GENERAL

2. The Planning Proposal

The Planning Proposal seeks to enable redevelopment of the site for a high density seniors living development comprising 10 residential flat buildings ranging in height between 11.5m, 22m and 24m.

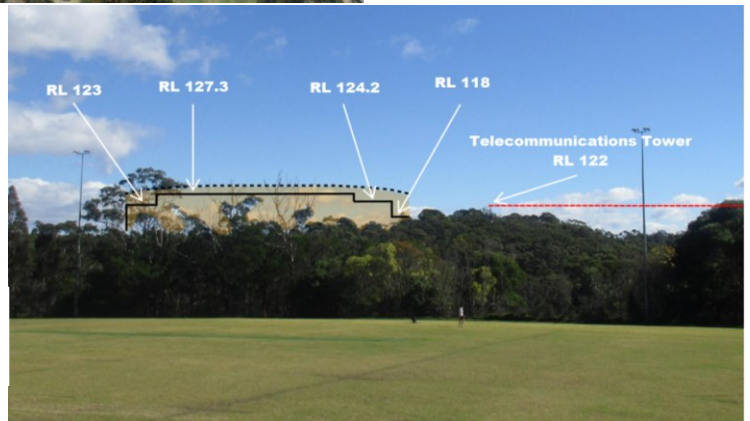
"When viewed from the street (Stanhope Road), the proposed development would have a low impact on the streetscape (maximum of 3-storeys along Stanhope Road), which is also will be screened by existing vegetation, reducing the any bulk and scale of the future buildings."

The proposed heights of 11.5m (3 story), 22m (6 storey), 24m (7 storey) cannot be hidden from Stanhope Road. The buildings heights will present a dominating bulk and scale to the streetscape of Stanhope Road, especially as the land slopes upwards, and is highly inappropriate in this low density residential area.

View 2
Headfort House, Stanhope Road, East Killara

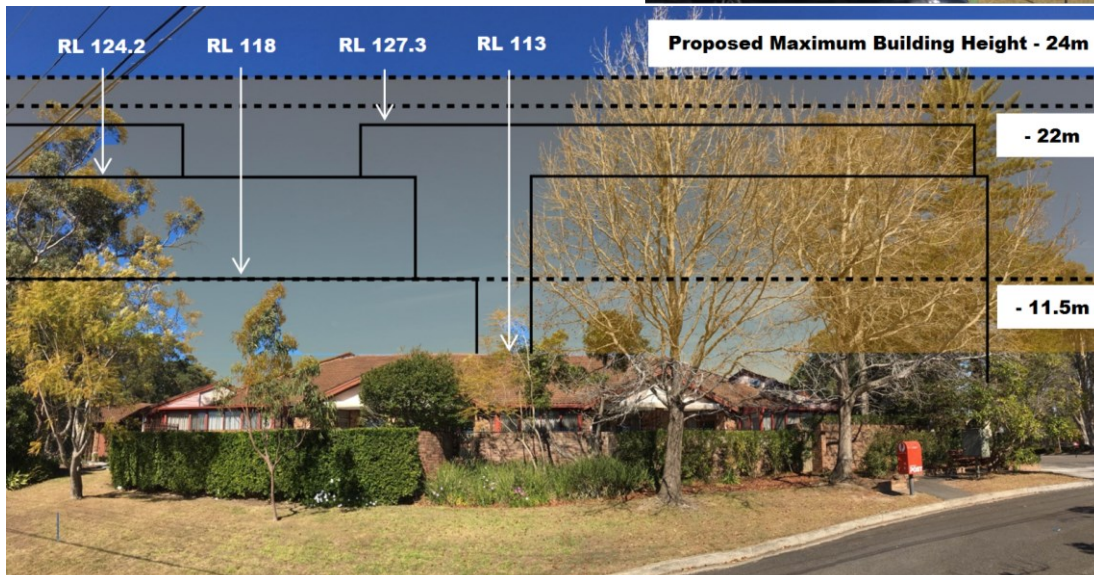
The heights of the proposal will materially alter the scenic and cultural landscape character of this area through the prominent bulk and scale that contradicts the low density residential and bushland area and the adjacent heritage conservation area.

Above are indicative bulk and scale annotations based on RLs of Planning Proposal building height (shown dotted) and built form outcomes of the Urban Design Report (shown as solid line).

Ku-ring-gai Bushfire Prone Land Map 2017

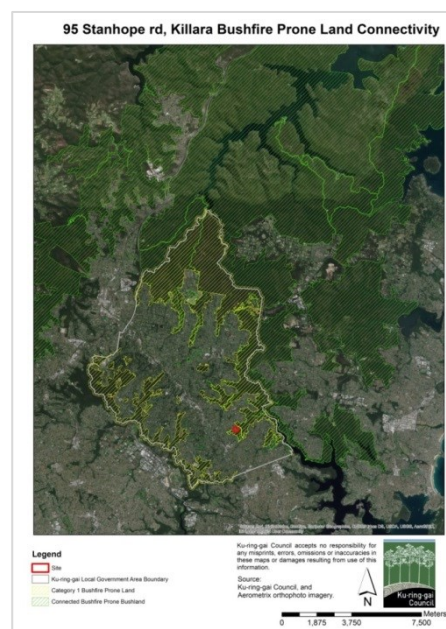
Council (as supported by their independent bushfire consultant, Australian Bushfire Protection Planners), maintain that the site is subject to significant exposure to bushfire attack from the south, east and the north east. This includes being joined by more than 38,500 ha of bushfire prone bushland, containing areas of steep terrain and being *"exposed to a 1.2 Kilometre fire path from the northeast with a potential head width of more than 300 metres and a fire path from the southeast has a length of more than 450 metres with a potential head width of more than 250 metres"* (pg.9 -10, Australian Bushfire Protection Planners April 2018), as shown within the below images.

KLEP 2015 Terrestrial Biodiversity Map

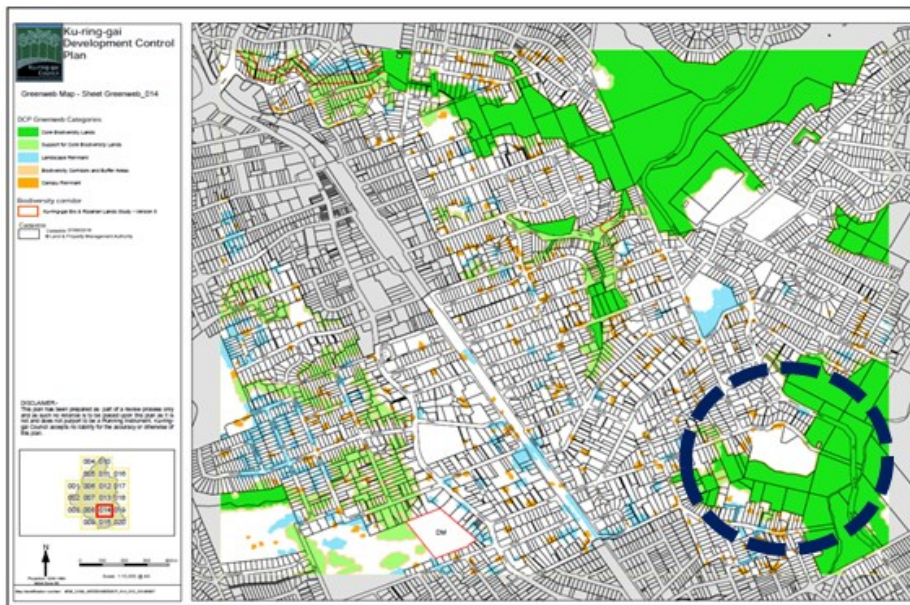
Contrary to this, the subject site is located includes and is adjacent to areas mapped as biodiversity lands as defined by the KLEP 2015 Terrestrial Biodiversity Map (see below), however the northern portion of the site, to which this Planning Proposal relates, is not identified as a biodiversity area.
